Referral Summary

Referral	Advice
Urban Design	<p><u>1 December 2022</u></p> <p>Overall, we support the proposed build to rent scheme.</p> <p><u>Built form</u></p> <ul style="list-style-type: none">- We support the overall 'U' shape form on the large site, in allowing access to daylight and outlook for residents.- Providing a large break in the front form alleviates the visual bulk of the massing on Bank St.- We recommend similar treatment (vertical separation or delineation), albeit to lesser depths, be applied along the other sides to alleviate the bulk, especially the southern façade viewed from Park St.- We support the residential amenities on podiums, however these will need to consider wind conditions from the surrounding built form as well as access to sunlight. <p><u>Cross block link</u></p> <p>The proposed cross block link is expected to primarily function as driveway access.</p> <p>We note:</p> <ul style="list-style-type: none">- It does not provide a connection right through the block to Bank St, rather taking people only as far as Lt Bank St which is currently a rather undesirable and lane with compromised personal safety.- the width of the laneway space is limited to o

SBO2

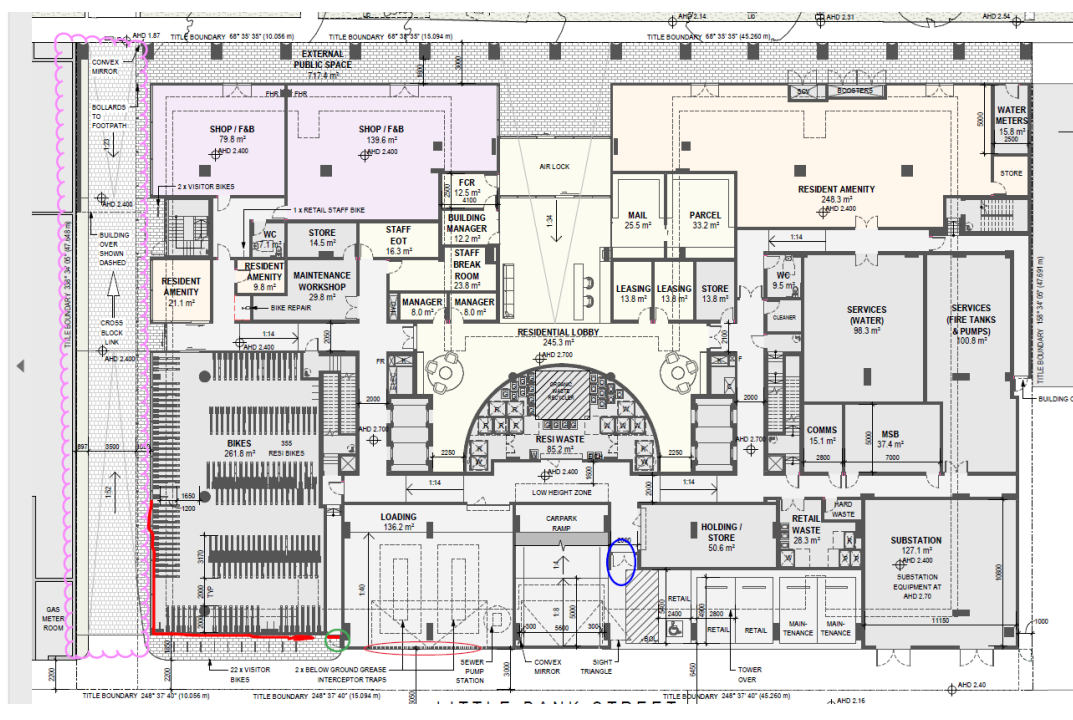
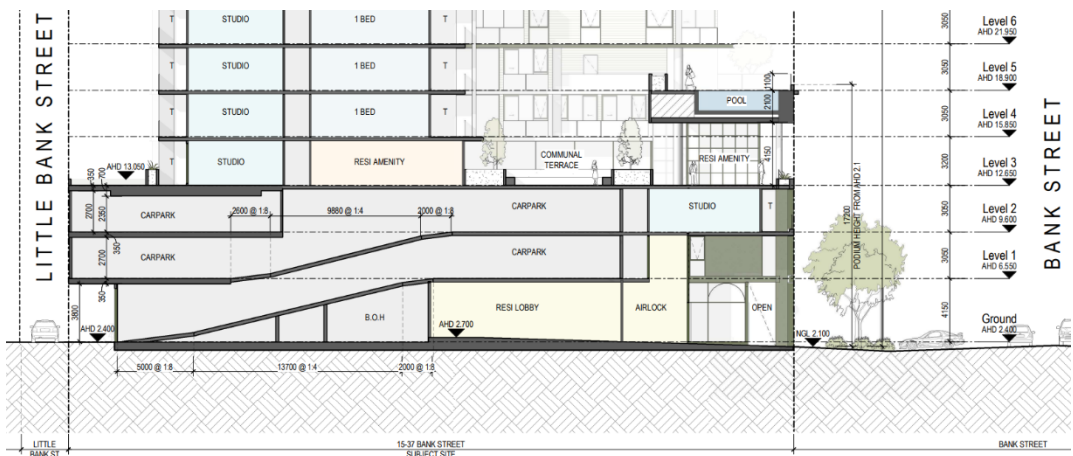
The designated flood level for the above property ranges from 2.310m AHD to 2.706m AHD (snip below). The SBO2 is encroaching into the rear of the property via the rear boundary as shown on the snip below. SBO2 encroaching into property 15-29 Bank Street is maximum.

The area within the SBO2 overlay at the rear includes:

- Sewer Pump Station/ Loading zone
- Bike parking
- Ramp to Carpark
- Entrances to Comms/store

- Based on the designated flood level and increased flood depth of 15-29 bank Street, to be conservative, maximum designated flood level of 2.706m AHD is adopted for the development at above address. Therefore, the minimum required finished floor level (FFL) for habitable area is 3m AHD (2.706 + 300mm) and non-habitable area is 2.856m AHD (2.706m +150mm)

- Loading area doesn't show the FFL on the plans. Is the access (circled in red) an access door? My concern is whether the area would be able to handle the load of floodwater or how the floodwater is going to be managed if it enters this area during any flood event.

- FFL of Holding/Store isn't shown on the plans. A flood barrier need to be installed at the entrance (circled in green and blue) to the minimum required FFL of 2.856m AHD (non-habitable area) to prevent water entering into the premises.

- To be conservative, the walls (In red) facing the SBO2 should also be watertight to the minimum required FFL of 2.856m AHD (non-habitable area).
- The height for installation of any electrical/gas points or switches (Loading area, store, Substation) should be a minimum of 600mm above the flood level.

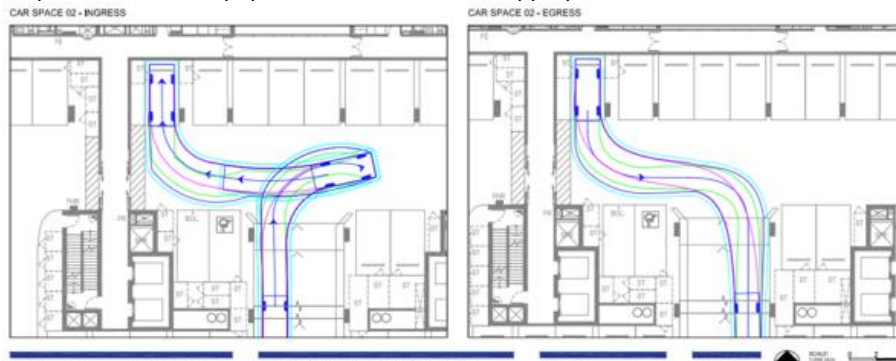
- Strategic Transport to provide further comment on car share spaces and how they are used as they do not typically like car share spaces reserved for residents of the development only and to be able to be used by all car share members.
- For this development to work, all car share spaces need to be allocated a car share vehicle I.e. not have any car share spaces empty.
- Storage unit adjacent to the below parking space to be removed to allow a forward entry as a reverse entry as depicted on the swept paths is not considered appropriate.

- Swept path diagram to be provided showing simultaneous access / egress at the property access point using one B99 vehicle and one B85 vehicle

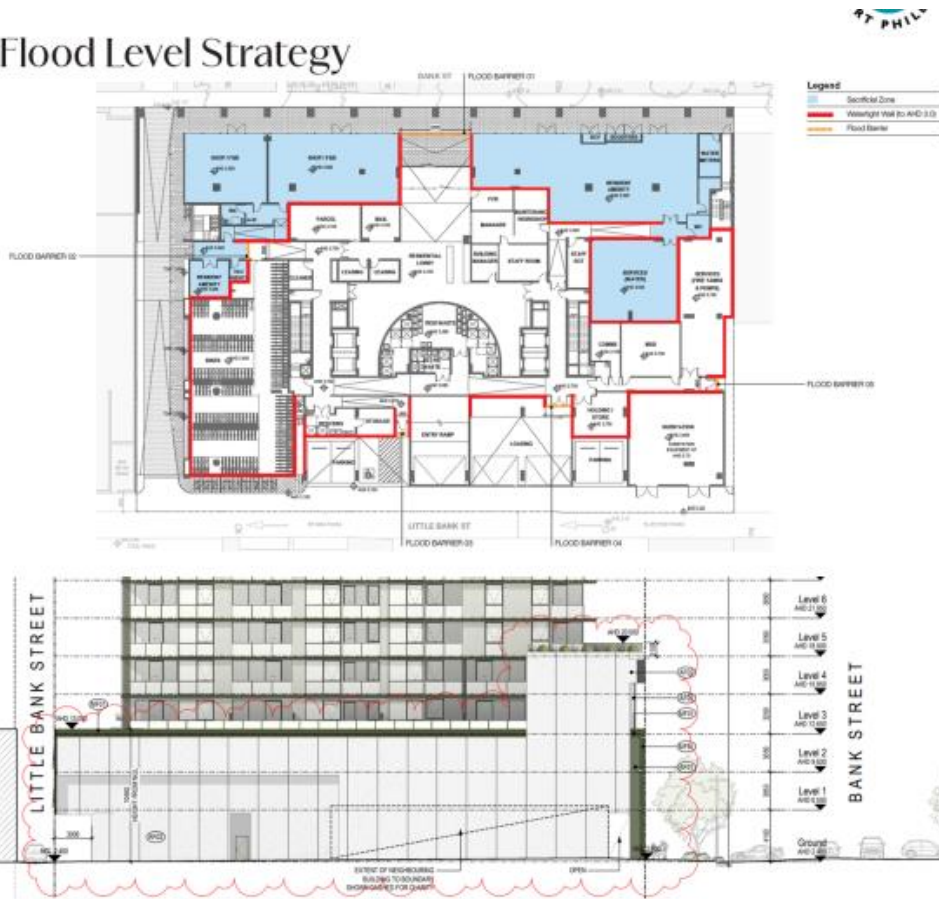
The designated flood level for the above property ranges from 2.310m AHD to 2.706m AHD (snip below). The SBO2 is encroaching into the rear of the property via the rear boundary as shown on the snip below. SBO2 encroaching into property 15-29 Bank Street is maximum.

The area within the SBO2 overlay at the rear includes:

- Sewer Pump Station/ Loading zone
- Bike parking
- Ramp to Carpark

- Entrances to Comms/store

Based on the designated flood level and increased flood depth of 15-29 bank Street, to be conservative, maximum designated flood level of 2.706m AHD is adopted for the development at above address. Therefore, the minimum required finished floor level (FFL) for habitable area is 3m AHD (2.706 + 300mm) and non-habitable area is 2.856m AHD (2.706m +150mm)

- We are satisfied with the proposed flood mitigations measures i.e proposed flood barrier and wall water tightening to meet the minimum FFL requirement for the development.
- We requested applicant to provide a written confirmation from Citipower stating that Citipower are satisfied with the proposed FFL of the substation equipment as 2.7m AHD. Has this been submitted?
